# PLANNING COMMISSION

Wednesday, May 08, 2024 at 5:30 PM

## AGENDA

# PLANNING COMMISSION STAFF REPORT

## Proposed Site

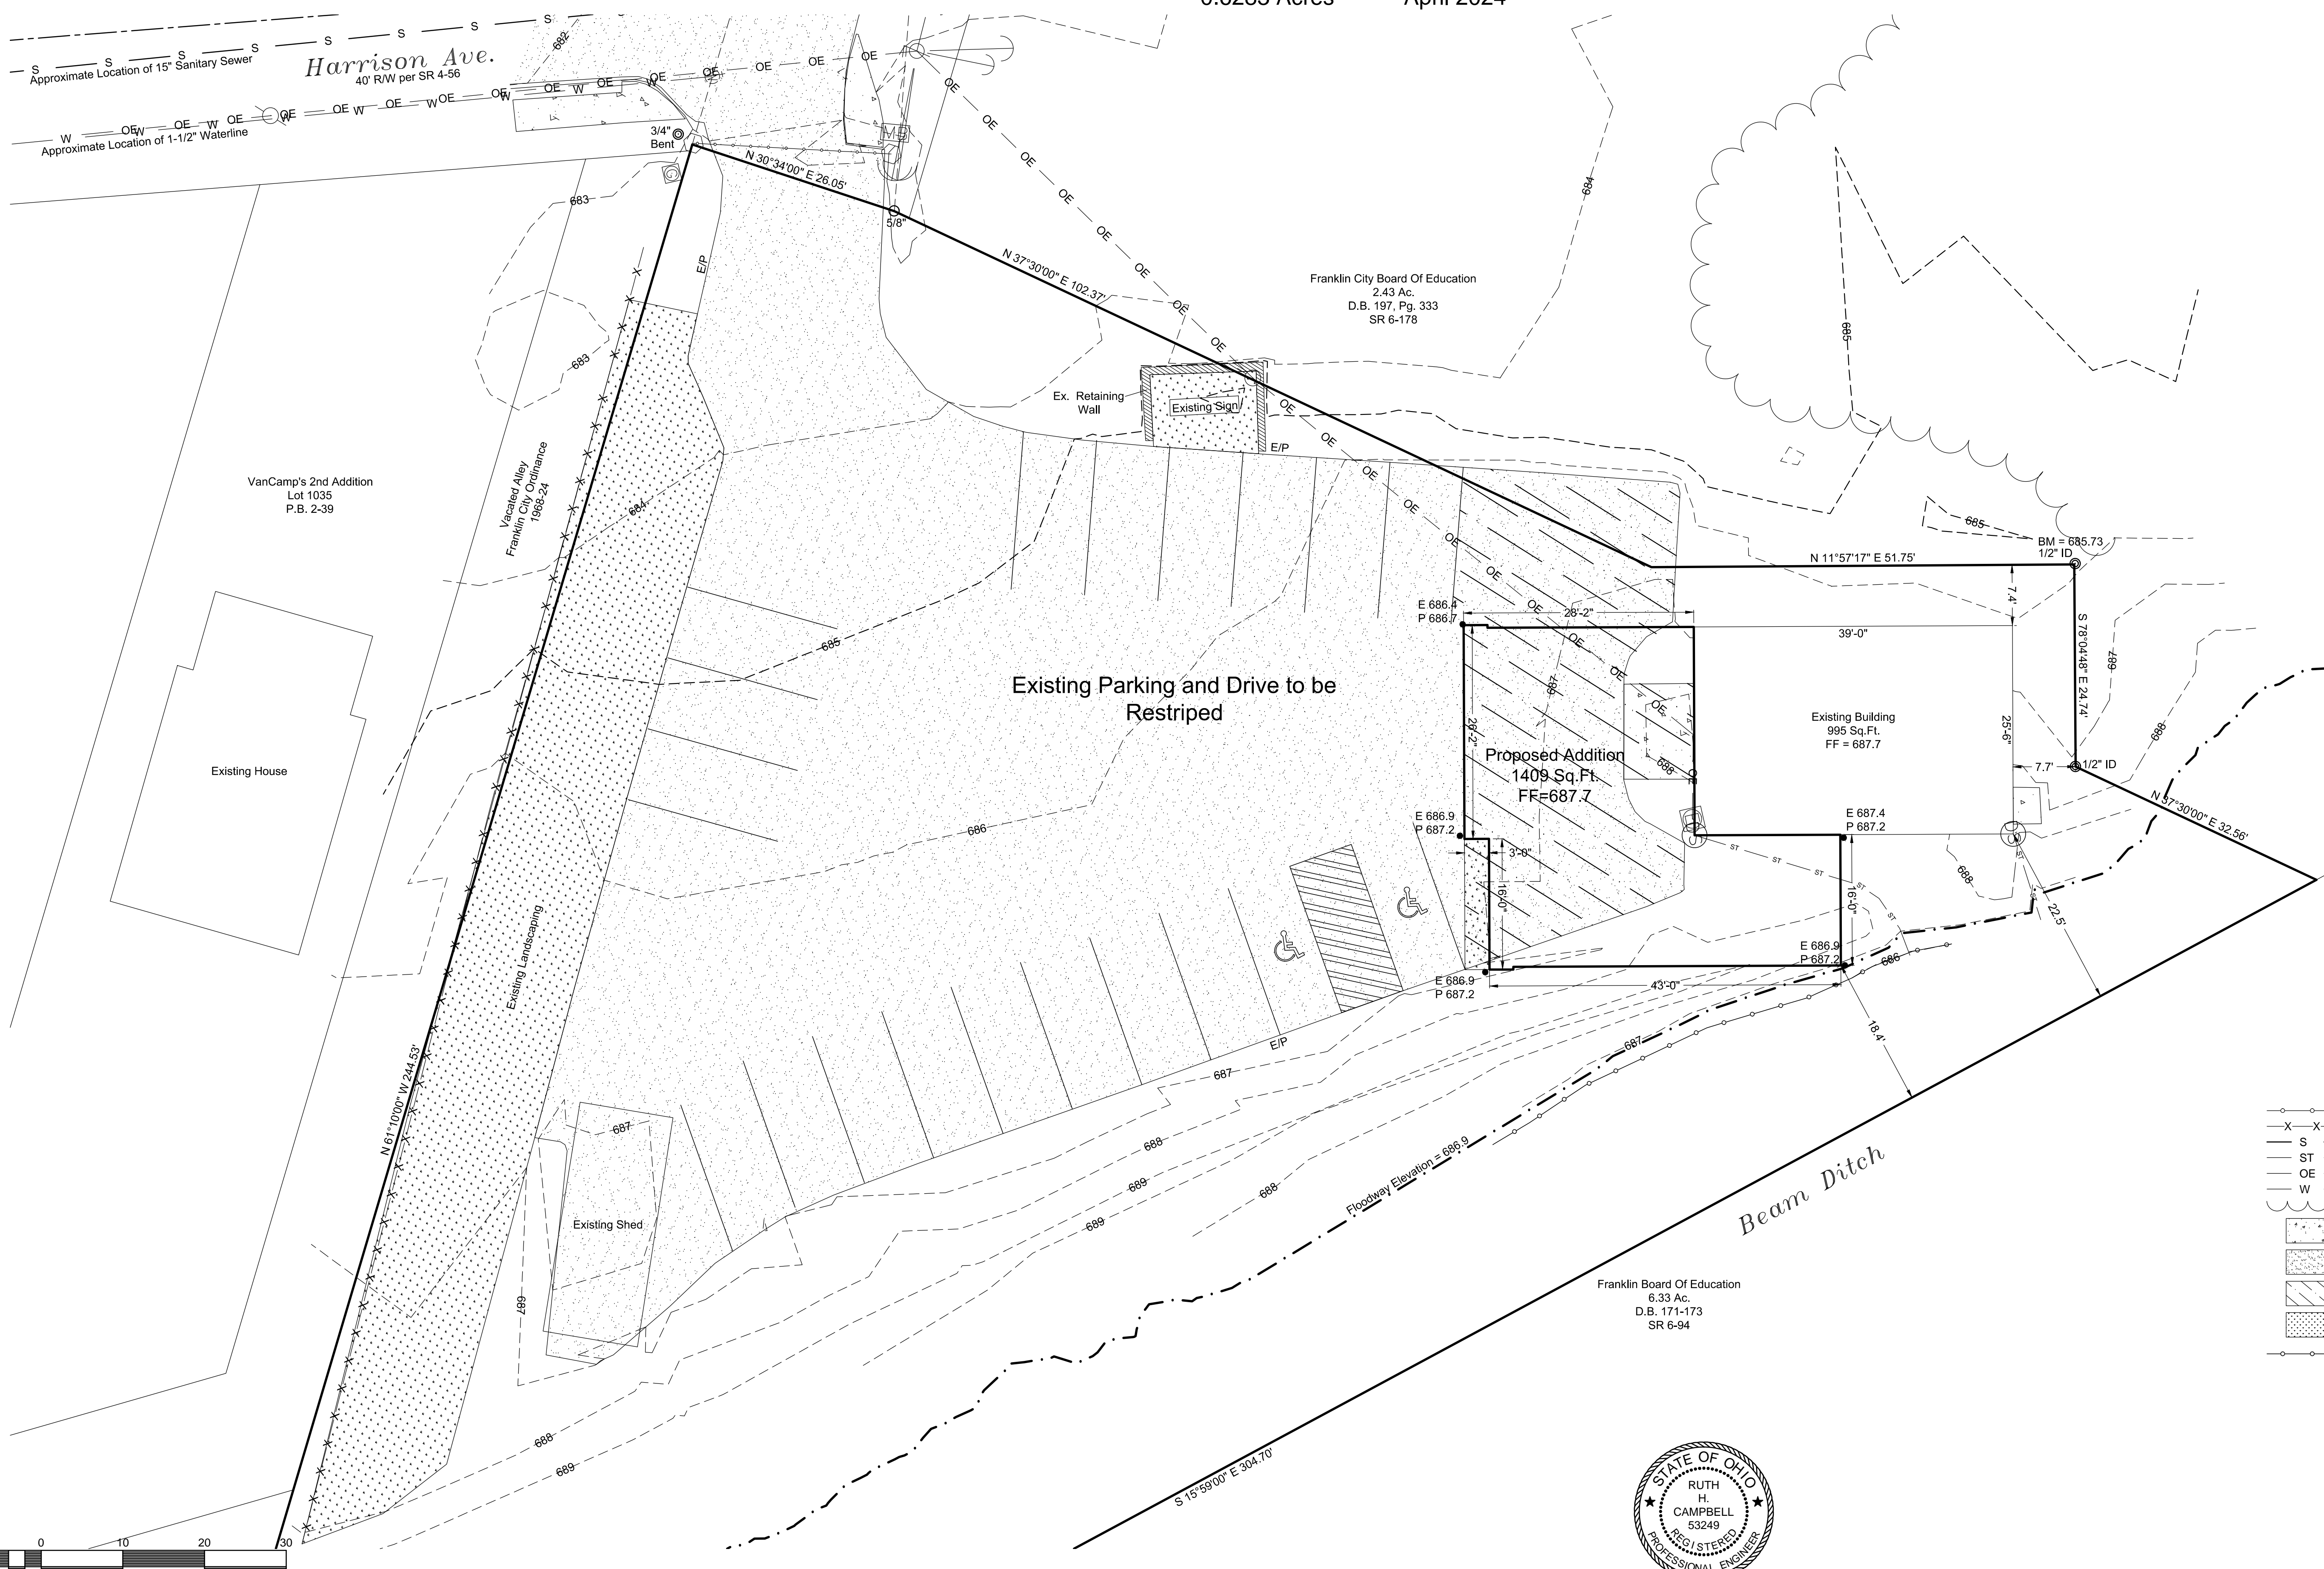
- **OFC 507.1**-Provide water flow data from nearest fire hydrant to building to show Available Fire Flow.
- **OFC 507.3**-Show that Available Fire Flow meets or exceeds Needed Fire Flow based on an approved method. Franklin Fire Division will accept Needed Fire Flow calculations based on OFC Appendix B. The City of Franklin has not adopted the OFC Appendix B, but will accept as an approved method.

- **OFC 507.5**-Show fire hydrant that is no farther than 400ft from all exterior walls of building. Please show location of fire hydrants and distance to all exterior walls of the building.

- Water supply requirements shall be approved by the Franklin Fire Division-AHJ prior to the start of construction.
- Site plan needed to show grade and access around building including creek that runs along side the building. Fire Department shall have 10ft wide level access to all exterior walls of the building.

LOCATION PLAN

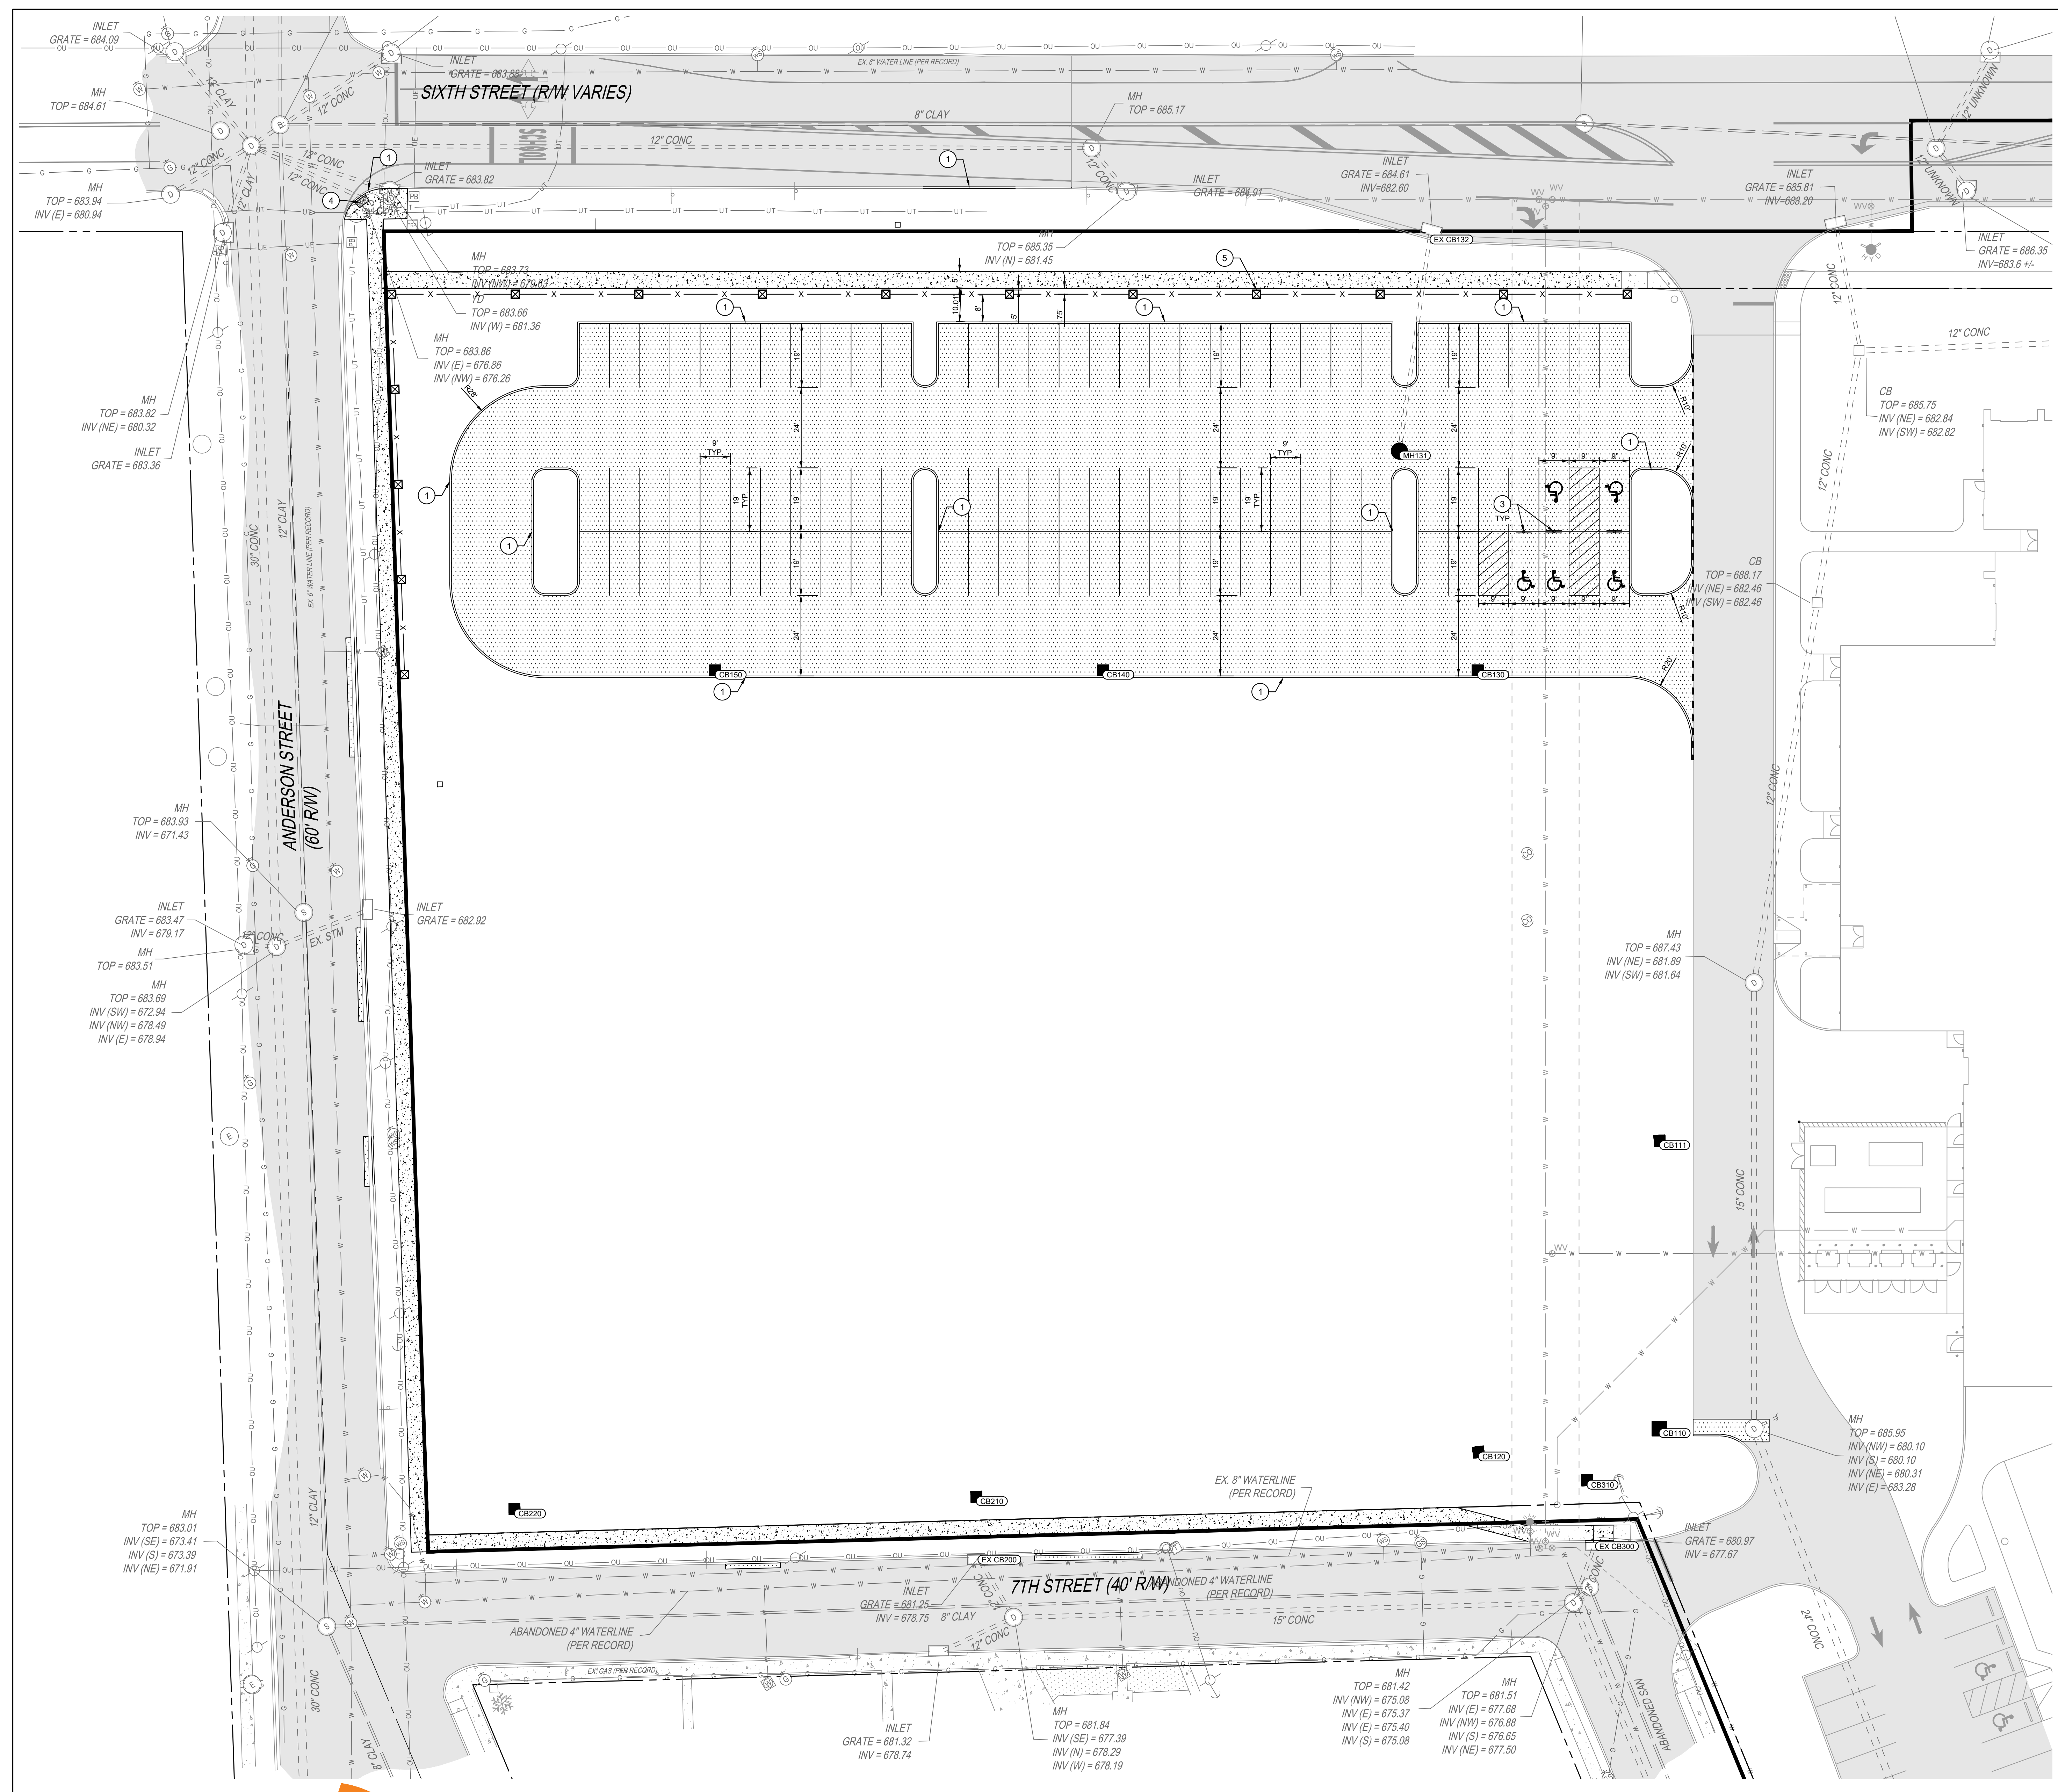
**Comments:** Site Plan: The proposed revision rotates the existing parking lot 90 degrees and provides a net increase of six standard parking spaces and one accessible parking space based on the approved Site Plan. At this time, no other development is proposed on parcel #0431178003 which will be left as open space. Access to the proposed parking lot will utilize the existing drives along East 6<sup>th</sup> Street and 7<sup>th</sup> Street. The applicant has not provided information regarding the need to demolish the existing parking facilities and reconstruct them with along East 6<sup>th</sup> Street other than stating that it is to serve the high school.

Parking: The proposed parking area increases the number of parking spaces over that which was approved by the Planning Commission in PC 22-02 to provide seven additional parking spaces. The applicant has not provided information regarding the need for additional parking spaces or why the reconfiguration of the parking lot is necessary.

Conformance with Adopted Plans: Major changes to major site plans are reviewed under the same process as major site plans. Section 1115.08(k) lists standards for major site plan approvals. The first approval standard is that the site plan complies with “all applicable” UDO requirements. Section 1107.11 of the UDO deals with downtown zoning districts, and states the intent and purpose of the downtown districts is “to implement the vision and recommendations of the Downtown Franklin Master Plan . . . .” The proposed revision to construct a parking lot that abuts East 6<sup>th</sup> Street and Anderson Street does not conform with the recommendations of the Downtown Franklin Master Plan which includes discouraging street front parking as a high priority action item for the Mixed Use Planning Area. The action item specifically states, “As new development, redevelopment, and infill development occurs within the district, promote active street fronts with parking areas to the side and rear of the building.” Additionally, the Mixed Use Planning Area is envisioned to be a dynamic, walkable district that includes a variety of uses which provide an attractive and engaging gateway into Downtown Franklin. The parking lot at the proposed location does not support this vision.

1. The applicant has not provided sufficient information regarding the need for a parking lot revision that is counter to the recommendations of the Downtown Franklin Master Plan for an increase in seven parking spaces.
  2. The applicant has provided no information on the proposed use of the remainder of the parcel #0431178001. Staff requests that the applicant provide additional context to how the remainder of the site is to be developed.
-
